Civil SSDA - Flood Assessment & Stormwater Management Report

**Lang Walker AO Medical Research
Building - Macarthur**

Prepared for BVN / 11 May 2022

Response to EES Comments

Figure A1 - Existing Overland Flow Path at Southern Site Boundary

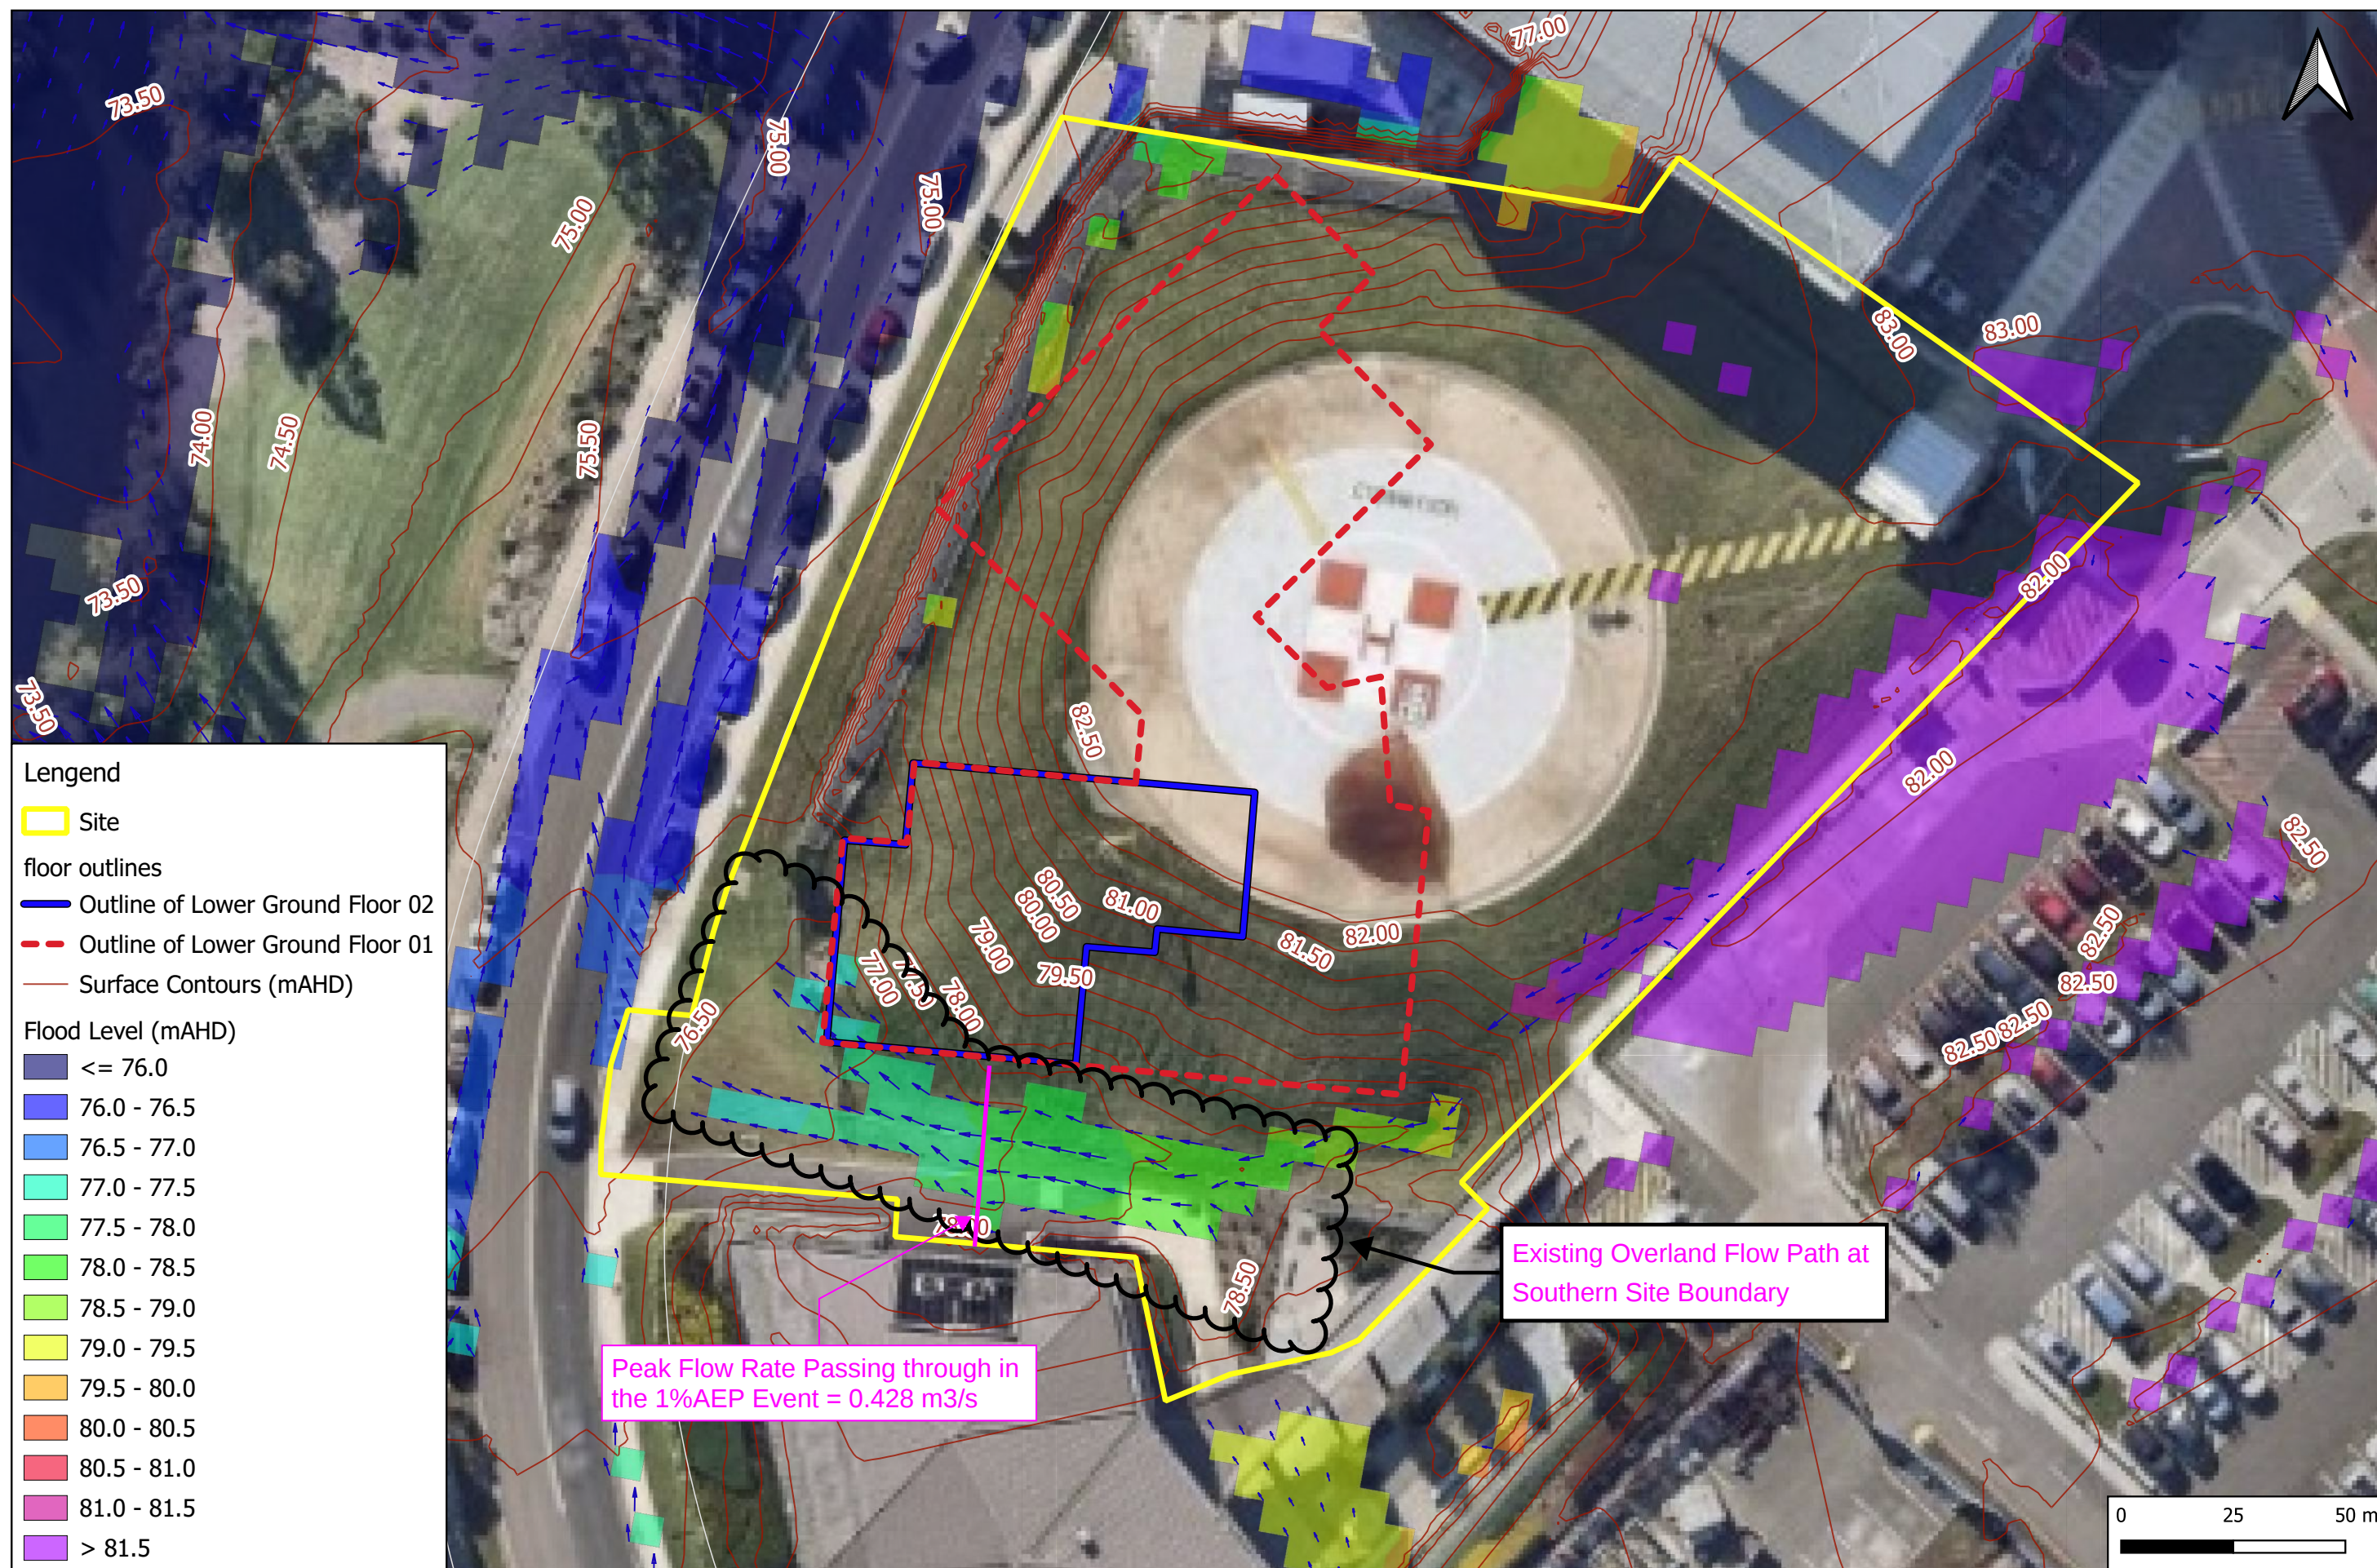
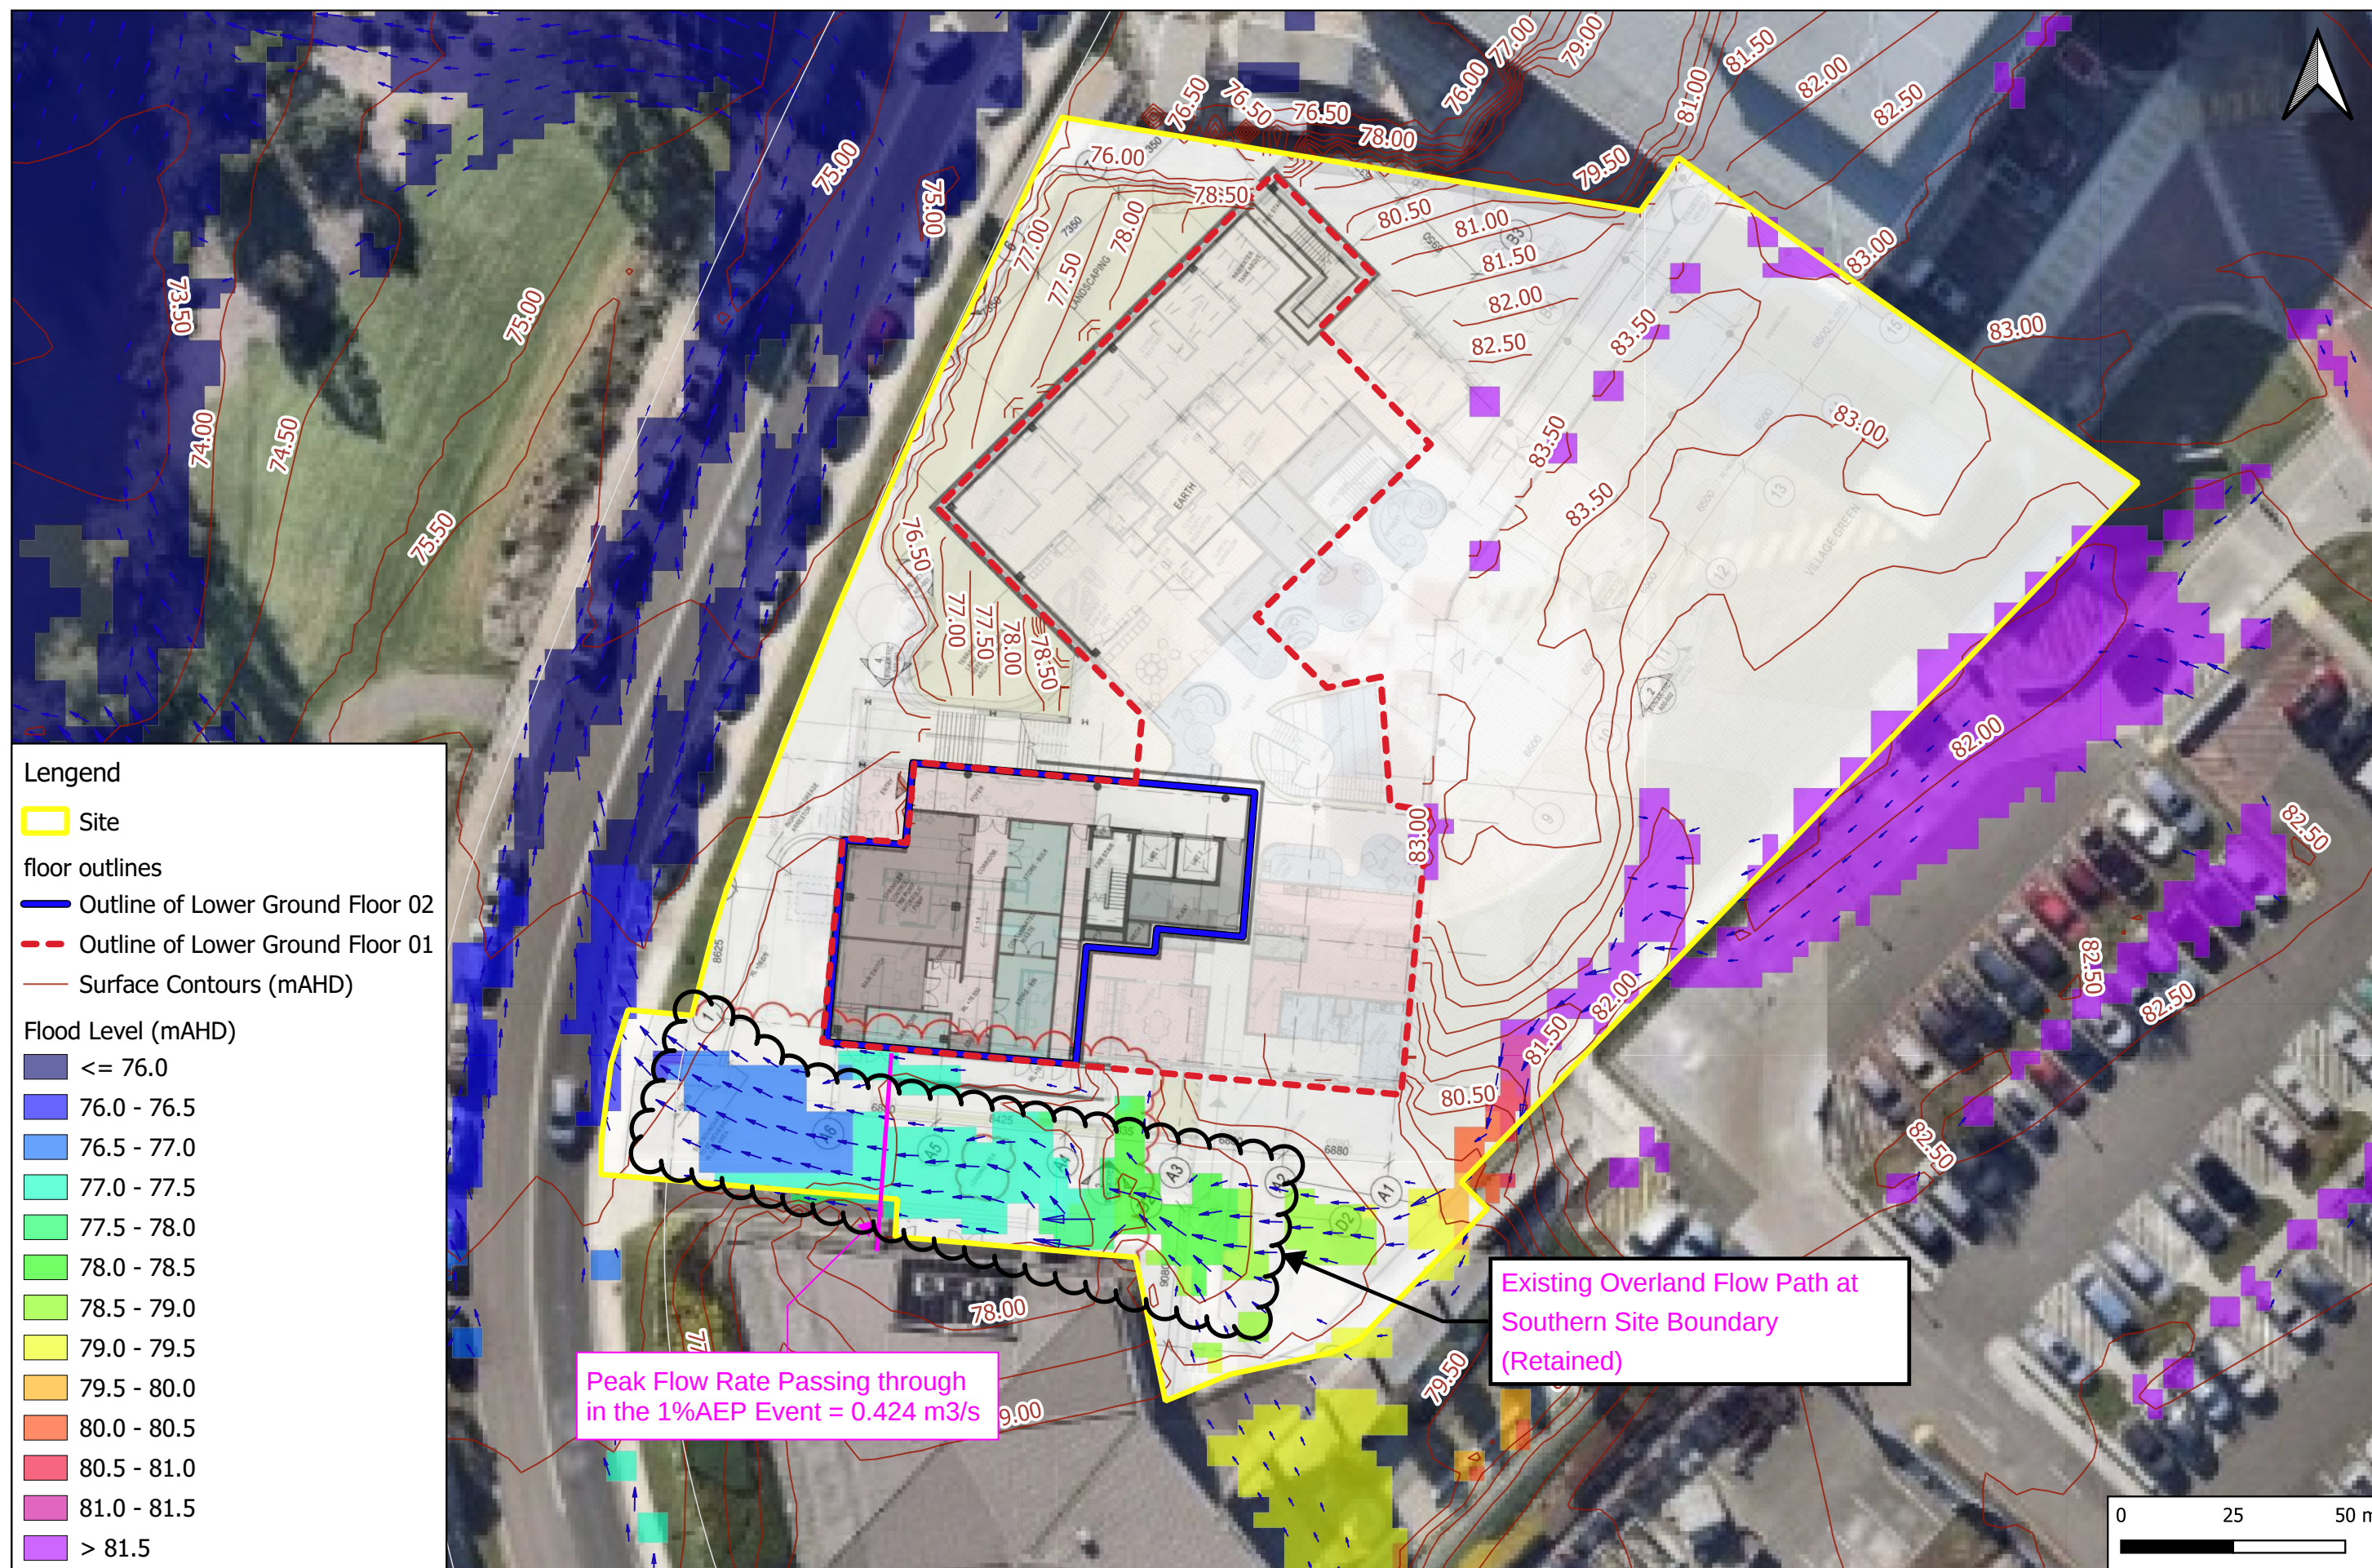
Campbelltown Council Comments	TTW Response
The site is impacted by overland flow from the car park at the hospital. Council discussed this matter with the proponent's engineers previously, and it was indicated that an overland flow path to the north of the proposed building would be included in the design. This flow path is not evident on the plans, However it is needed and should collect the overland flow and manage its discharge to the pipe drainage system in Parkside Crescent. Overland flows over the footpath, or discharge to the road surface are not permissible.	- The existing overland flow path for the upstream catchment (including the existing car park east of the site) is along the southern site boundary which drains onto the Parkside Crescent as shown in Figure 8 and presented clearly in Figure A1 of Attachment A. - The existing overland flow path has been maintained in the proposed development along the southern site boundary (see Figure 16 and Figure A2 of Attachment A). - The proposed pipe drainage system for the site is designed to cater for storm events of up to 5% AEP (minor event) as per the ARR minor and major drainage system requirements. - Minor storm event for the site is identified based on Table 4.5 of the Campbelltown Council DCP (2015). - The existing pipe network has been assumed to be fully blocked in the 1% AEP and PMF events. This approach provides more conservative results as opposed to the condition where the additional drainage capacity of the pipes is considered. - The existing stormwater pipe network in Parkside Crescent does not have capacity to convey the existing overland flows in major flood events e.g., a 1% AEP flood or greater. - The proposed development does not have any adverse impact on the existing flood levels or overland flow paths outside the development area, including the Parkside Crescent and the footpath. - The Proposed condition slightly reduces the 1% AEP existing overland flow that runs along the southern boundary, refer to Figure 25.
